**Town of Brookline  
Massachusetts**

# **Walnut Street Traffic Calming Evaluation**

October 2003

**BETA Group, Inc.**

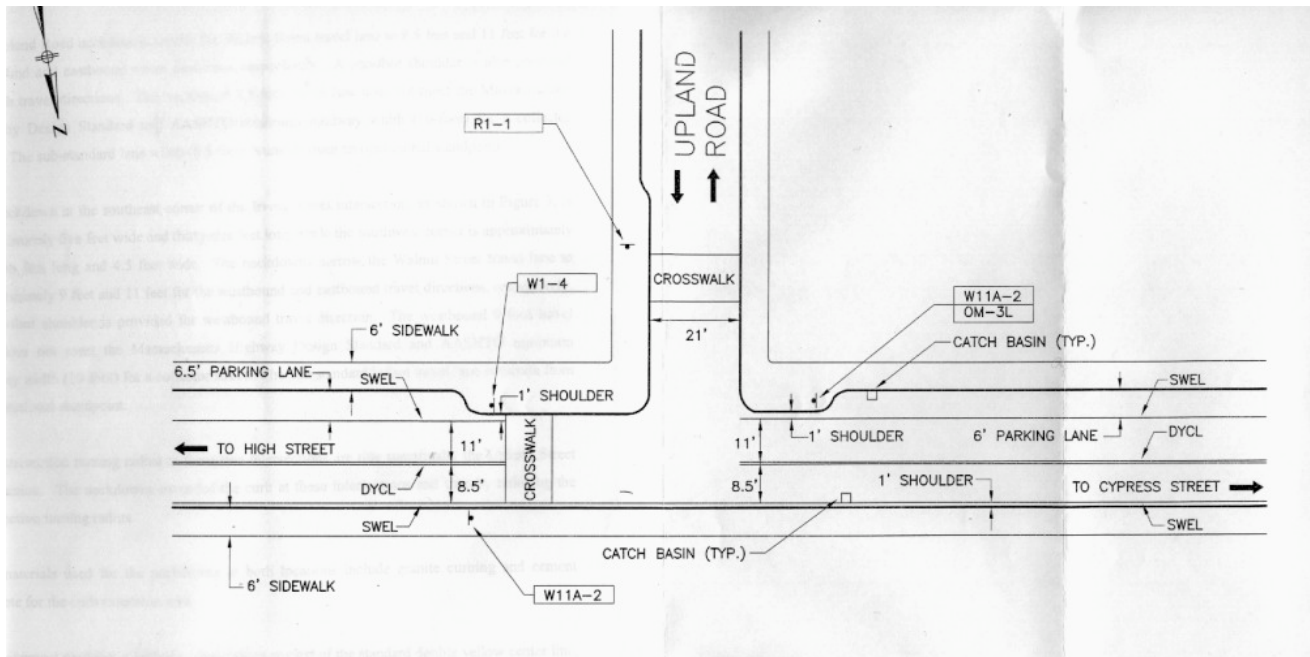
Construction plans were available for referencing the traffic calming devices on Walnut Street. In addition, field measurements were taken and compared to the construction plans. Figure No. 2 shows the neckdown at Upland Road/Walnut Street intersection. The neckdown at the southeast corner of the Upland Road intersection is approximately forty feet long and extends five feet into the roadway from the existing sidewalk edge. The neckdown at the southwest corner is approximately twenty-three feet long and extends approximately 4.5 feet into the roadway.

The Upland Road neckdowns narrow the Walnut Street travel lane to 8.5 feet and 11 feet for the westbound and eastbound travel directions, respectively. A one-foot shoulder is also provided for both travel directions. The westbound 8.5-foot travel lane does not meet the Massachusetts Highway Design Standard and AASHTO minimum roadway width (10-foot) for a collector street. The sub-standard lane width (8.5 feet) is unsafe from an operational standpoint.

- The westbound roadway width (8.5') and parking lane width (6.0') do not meet AASHTO and MassHighway design standards which call for a minimum of 10' travel lanes and 7' parking lane for collector roads.
- The crosswalks on the Upland Road and Walnut Street approach are located too far away from the intersection, approximately 15 feet south and east of the intersection respectively.
- The turning radius for vehicles turning in and out of Upland Road from Walnut Street is tight due to the neckdown curb extension.
- There are no catch basins provided at the eastern side of the neckdown curb extension.

- Restrip travel lane width and parking lane to provide a 7 foot parking lane and 10 foot travel lane to conform with AASHTO and MassHighway design standards for parking and lane widths for collector roads.
- Consider relocating the crosswalks closer to the intersection.
- Consider improving the curb extension radius at the intersection to allow adequate vehicle turning radius from Upland Road onto walnut Street.
- Install catch basins east of the neckdown curb extension to prevent ponding of water at the curb extension.

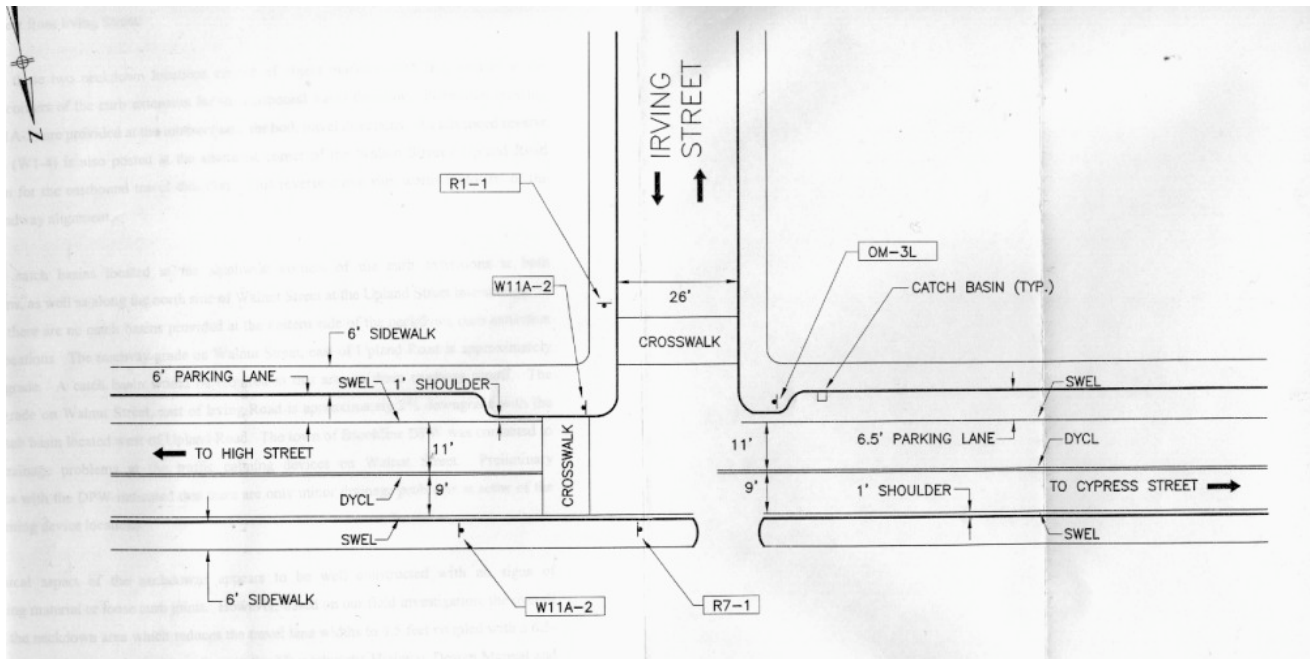
The neckdown at the southeast corner of the Irving Street intersection, as shown in Figure 3, is approximately five feet wide and thirty-one feet long while the southwest corner is approximately fourteen feet long and 4.5 feet wide. The neckdowns narrow the Walnut Street travel lane to approximately 9 feet and 11 feet for the westbound and eastbound travel directions, respectively. A one-foot shoulder is provided for westbound travel direction. The westbound 9-foot travel lane does not meet the Massachusetts Highway Design Standard and AASHTO minimum roadway width (10-foot) for a collector street. The sub-standard 9-foot travel lane is unsafe from an operational standpoint.

- The westbound roadway width (9') and parking lane width (6.0') do not meet AASHTO and MassHighway design standards.
- Vehicles are parked too close to the southwest corner of the intersection restricting sight lines at the Irving Road approach.
- The turning radius for vehicles turning in and out of Irving Road from Walnut Street is tight due to the neckdown curb extension.
- There are no catch basins east of Irving Road.

- Restrip travel lane and parking lane widths to provide a 7 foot parking lane and 10 foot travel lane to conform with AASHTO and MassHighway design standards for travel lane and parking widths for collector roads.
- Consider improving the curb extension radius at the intersection to improve vehicle turning in and out of Irving Road.
- Restrict parking 20 feet from the curb extension at the southwest corner to improve sight lines for the Irving Road approach.
- Install catch basins east of the neckdown curb extension to prevent ponding of water at the curb extension.

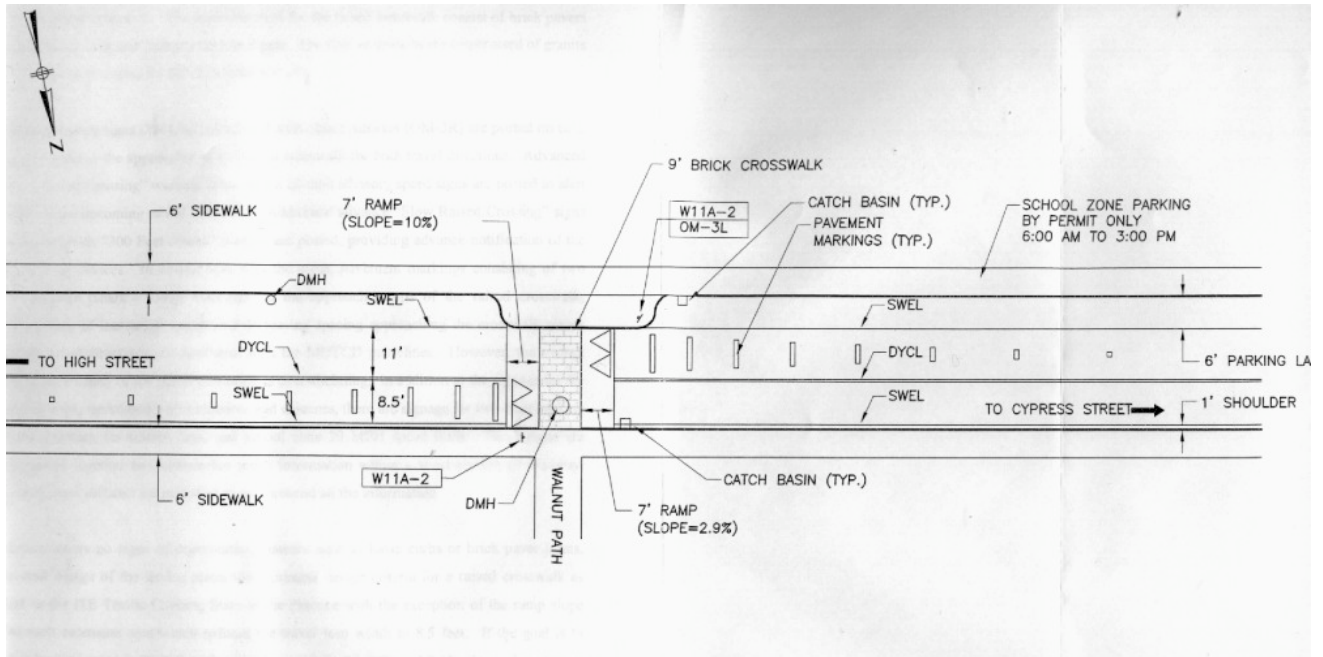
The crosswalk is approximately nine feet wide with seven-foot ramps. The height of the raised crosswalk is approximately six inches. Field measurements utilizing the Smart Level revealed that the ramp slopes are 10.0% for the east side and 2.9% for the west side.

The device shows no signs of deteriorating material such as loose curbs or brick paver joints. The overall design of the device meets the minimum design criteria for a raised crosswalk as outlined in the ITE Traffic Calming State of the Practice with the exception of the ramp slope and the curb extension area which reduces the travel lane width to 8.5 feet. If the goal is to reduce vehicular speed to 20 mph at the raised crosswalk, the 10% and 2.9% slopes do not meet the ITE design standard, which calls for 8% ramp slopes.

The 10% ramp slope exceeded the industry standard for raised crosswalk of 8% ramp slope for a 20 mph travel speed. The 10% slope will create safety problem for vehicle crossing the raised crosswalk and vehicle may air borne and bottom out as they depart from the device. The 2.9% slope will allow vehicles to cross the raised crosswalk at speeds greater than the 20 mph posted advisory speed. In addition, the transition between the existing roadway and the crosswalk ramps

- The raised crosswalk ramp slopes (10% and 2.9%) were not constructed to industry standards for a 20 mph design speed which calls for an 8% slope. The reduced ramp slopes permit vehicles to traverse the raised crosswalks at speeds greater than the posted 20 mph advisory speed. Thus causing vehicles to bottom out as they depart the raised crosswalk and causing pavement damage and potential safety concerns.

- Restrip travel lane and parking lane widths to provide a 7 foot parking lane and 10 foot travel lane to conform with AASHTO and MassHighway design standards for travel lane and parking widths for collector roads.
- Improve raised crosswalk ramp slopes to meet industry standards for a 20 MPH design speed, which calls for an 8% slope.
- Install catch basins east of the raised crosswalk to prevent ponding of water at the ramp at the eastern edge of the crosswalk.
- Replace the existing pedestrian crossing sign (W11A-2) with "Raised Crossing" sign.
- Removed advance signage for raised crosswalk. Also, see signage improvements section.

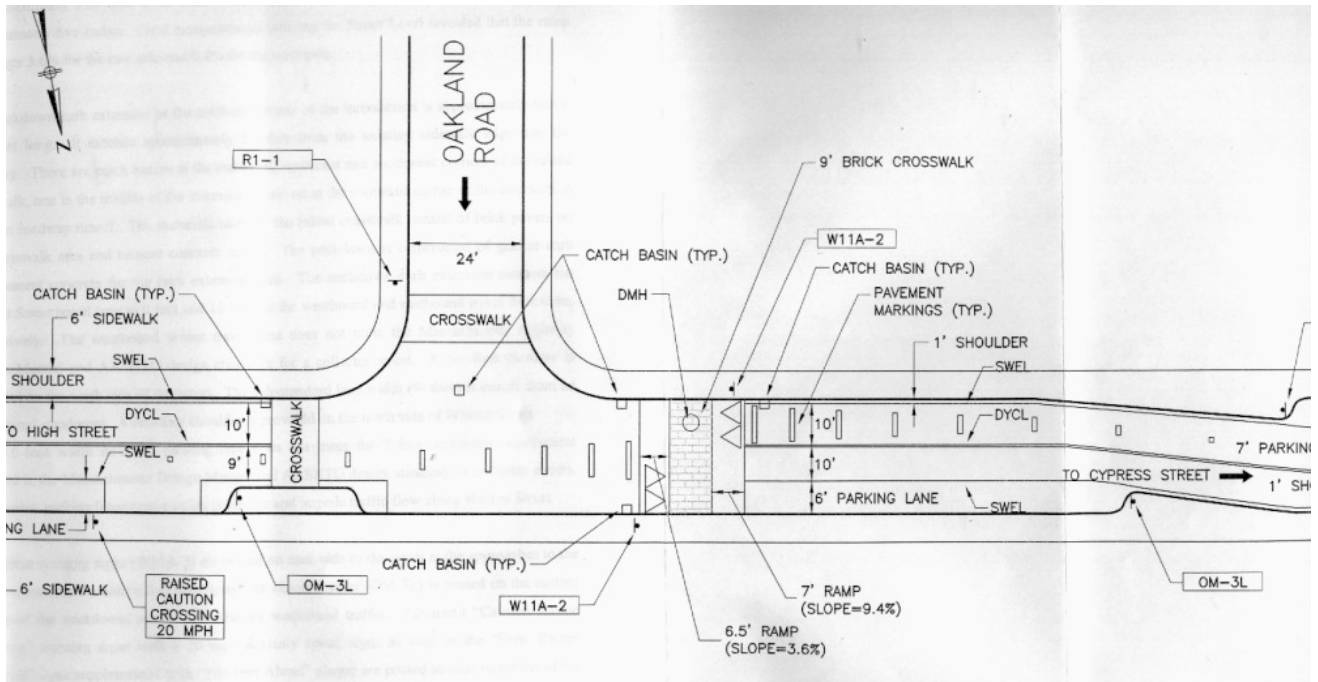
is approximately nine feet wide with 7-foot ramps. The height of the raised crosswalk is approximately five inches. Field measurements utilizing the Smart Level revealed that the ramp slopes are 3.6% for the east side and 9.4% for the west side.

The west side of the ramp slope (9.4%) exceeds the industry standard for raised crosswalk which

is 8% for a 20 mph travel speed. However, the east side of the slope (3.6%) is less than 8%, which allows vehicles to cross the raised crosswalk at speeds greater than the 20 mph posted advisory speed. The substandard slope accounts for the pavement injury that exists in the area departing the raised crosswalk from both the travel directions. The scraped pavement indicates that vehicles are traveling at high speeds exceeding the posted 20 mph advisory speed when crossing the raised crosswalk and bottoming out as they depart from the device. The speeding at the raised crosswalk is also due to the wide spacing between the two raised crosswalks.

- The raised crosswalk ramp slopes (3.6% and 9.4%) were not constructed to industry standards for a 20 mph design speed which calls for an 8% slope. The reduced ramp slopes permit vehicles to traverse the raised crosswalks at speeds greater than the posted 20 mph advisory speed. Thus causing vehicles to bottom out as they depart the raised

- Restrip travel lane and parking lane widths to provide a 7 foot parking lane and 10 foot travel lane to conform with AASHTO and MassHighway design standards for travel lane and parking widths for collector roads.
- Reconstruct raised crosswalk ramp slopes to meet industry standards for a 20 MPH design speed, which calls for an 8% slope.
- Replace the existing pedestrian crossing sign (W11A-2) with "Raised Crossing" sign.
- Removed advance signage for raised crosswalk. Also, see signage improvements section.

Figure 6

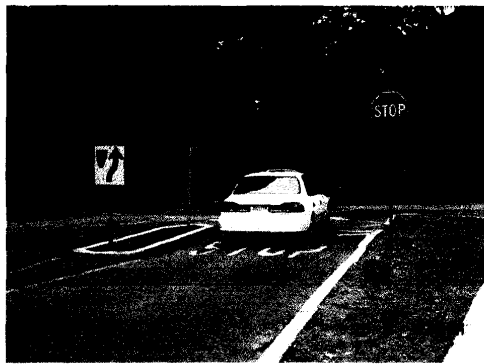
The overall construction of the Median/Island Treatment and Curb Extension is well constructed with no signs of deteriorating material or loose curb joints. Similarly, the overall design of the device meets the minimum design criteria for a curb extension and median/island treatment.

Although the southwestern portion of the triangular intersection is evaluated to be satisfactory from a traffic calming standpoint, we recommend continued monitoring of the overall triangular intersection locations for traffic safety operations.
